Access Compliance Report

Public Rights-of-Way

(Curb Ramps)

Intersection ID: N/A	Main Street: TRYON ST	Cross Street: NORTHCHASE DR	Location: SE
ADA ID: 6620896446B4	Ramp Type: BlendTrans2	Initial Pass/Fail: Pass	Overall Compliance: No
Codes/Mitigation Info/Possible Solution		Field Measurements/Component Compliance	
Severity Score: 10

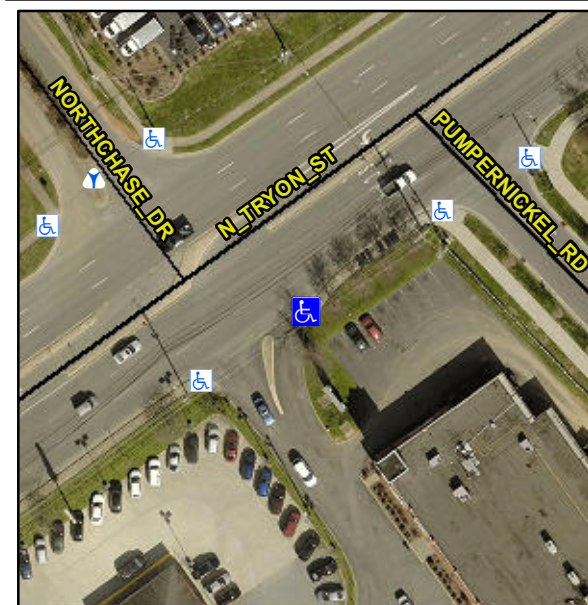
Not Found, R305

Compliance	Description	Data	Compliance	Description	Data
N/A	Ramp Length (in)	60.0	Yes	BlendTrans Slope (%)	1.8
Yes	Ramp Width (in)	150.0	Yes	BlendTrans XSlope (%)	1.3
N/A	Flare Type LT	Sloped	N/A	Flare Type RT	Sloped
N/A	Flare Slope LT (%)	4.8	N/A	Flare Slope RT (%)	10.6
N/A	Flare Traversable LT?	No	N/A	Flare Traversable RT?	No
N/A	Landing Length (in)	N/A	No	DWS Provided?	No
N/A	Landing Width (in)	N/A	N/A	DWS Contrast?	No
N/A	Landing Slope (%)	N/A	N/A	DWS Length (in)	N/A
N/A	Landing X Slope (%)	N/A	N/A	DWS Full Width?	No
N/A	Landing Curb? (Y/N)	No	N/A	DWS Offset (in)	N/A
N/A	Shared Landing?	No			
Yes	Gutter Ponding?	No	Yes	Gutter Slope (%)	3.9
Yes	Gutter Lip Ht (in)	0.0	Yes	Gutter X Slope (%)	0.1
N/A	Painted X Walk1?	No	N/A	Painted X Walk2?	No
	X Walk 1 Direction	To NW		X Walk 2 Direction	To SW
	X Walk 1 Width (in)	N/A		X Walk 2 Width (in)	N/A
	X Walk 1 Slope (%)	0.5		X Walk 2 Slope (%)	1.3
	X Walk 1 X Slope (%)	0.8		X Walk 2 X Slope (%)	1.5

N/A	Ramp inside XWalk1?	N/A	N/A	Ramp inside XWalk2?	N/A
	Road Slope (%)	0.4		Clear Space?	Yes
	Road X Slope (%)	1.0	N/A	Clear Space to XWalk (in)	N/A
Yes	Any Obstructions?	No	Yes	Storm Grate/Utility Hazard?	No
	Obstruction Type			Storm Grate/Utility Type	
		N/A			N/A
			Yes	Surface Condition? (G/P)	Good
			No	Curb Slope (%)	7.4

Remove & Replace Curb Ramp With Two New Directional Ramps or Equivalent.
